AMENDMENTS TO THE DRAWINGS

REMARKS

Fig-2

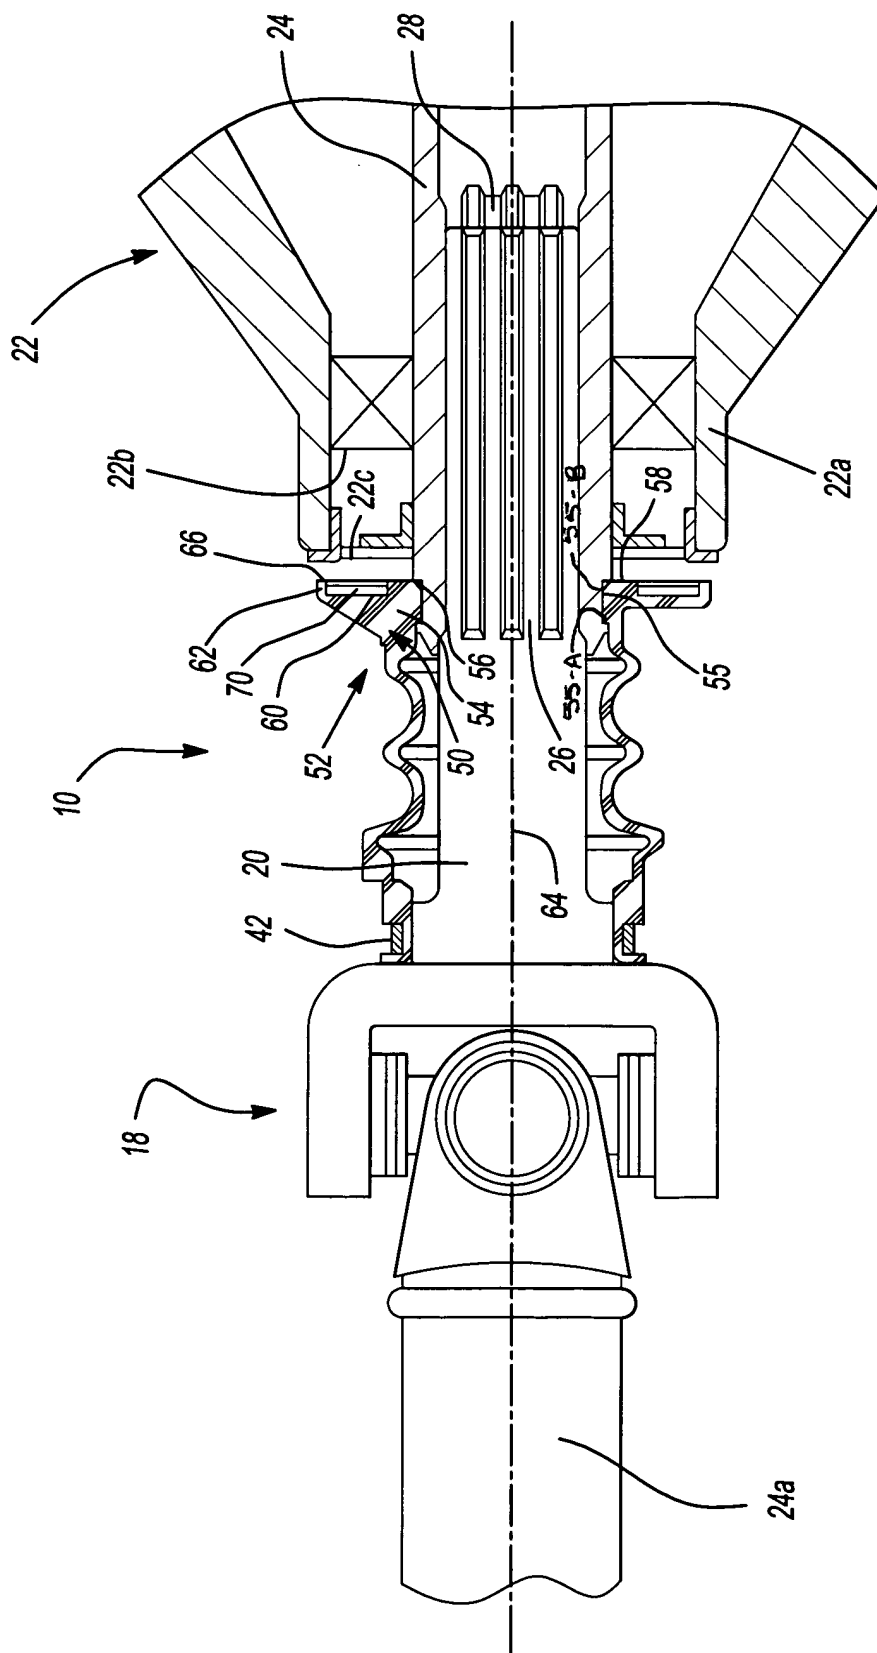
The attached “Replacement Sheet” of drawings includes changes to Figure 2. Reference numerals 55A and 55B have been added to Figure 2. Applicant has also included a marked-up copy of this drawings sheet.

Concerning the axial spacing of the annular groove relative to the axial end of the first shaft, Applicant notes that the patent application as filed, conveys with reasonable clarity to a person of ordinary skill in the art that the mating groove 55 is proximate but spaced apart from an axial end of the shaft 24. Applicant notes that this is clearly shown in Figure 2.

Concerning the first and second sidewalls of the annular groove, Applicant notes that the patent application as filed, conveys with reasonable clarity to a person of ordinary skill in the art that the mating groove 55 includes a first sidewall and a second sidewall that

is spaced apart from the first sidewall in an axial direction along the output shaft. Applicant notes that this is clearly shown in Figure 2.

Concerning the abutment of the flange seal against the first sidewall, Applicant notes that the patent application, as filed, conveys with reasonable clarity to a person of ordinary skill in the art that the attachment portion 54 abuts the first sidewall to thereby retain the flange seal portion 50 to the splined shaft 24. See Figure 2.
